Access Compliance Report

Public Rights-of-Way

| Intersection ID: 18627 | Main Street: CEDARBARK_DR | Cross Street: CLIFTON_MEADOW_DR | Location: E |
| ADA ID: 515772A2373E | Ramp Type: PerpDiag | Initial Pass/Fail: Fail | Overall Compliance: No |

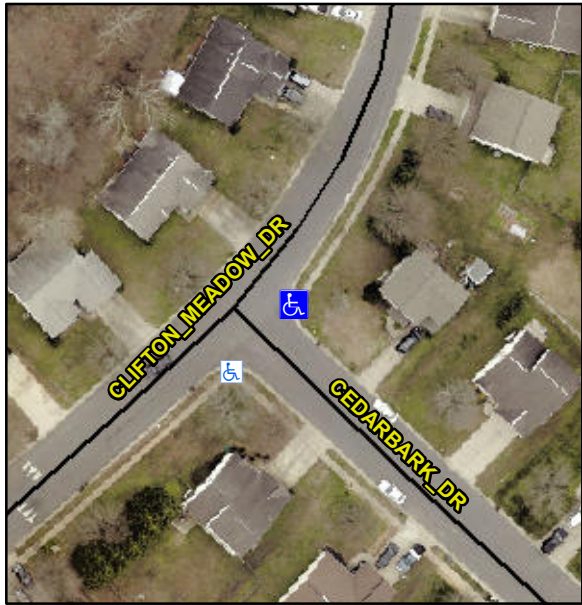
| Codes/Mitigation Info/Possible Solution | | Field Measurements/Component Compliance | |
| Severity Score: 13.75 | | | |

PROW/ADA:
R304.2.2, R304.5.3

| Compliance | Description | Data | Compliance | Description | Data |
|------------|-----------------------|-------|------------|-----------------------------|-------|
| N/A | Ramp Length (in) | 37.0 | No | Ramp Slope (%) | 9.7 |
| Yes | Ramp Width (in) | 48.0 | No | Ramp XSlope (%) | 4.0 |

Possible Solutions:
Remove & Replace Curb Ramp With Two New Directional Ramps or Equivalent.
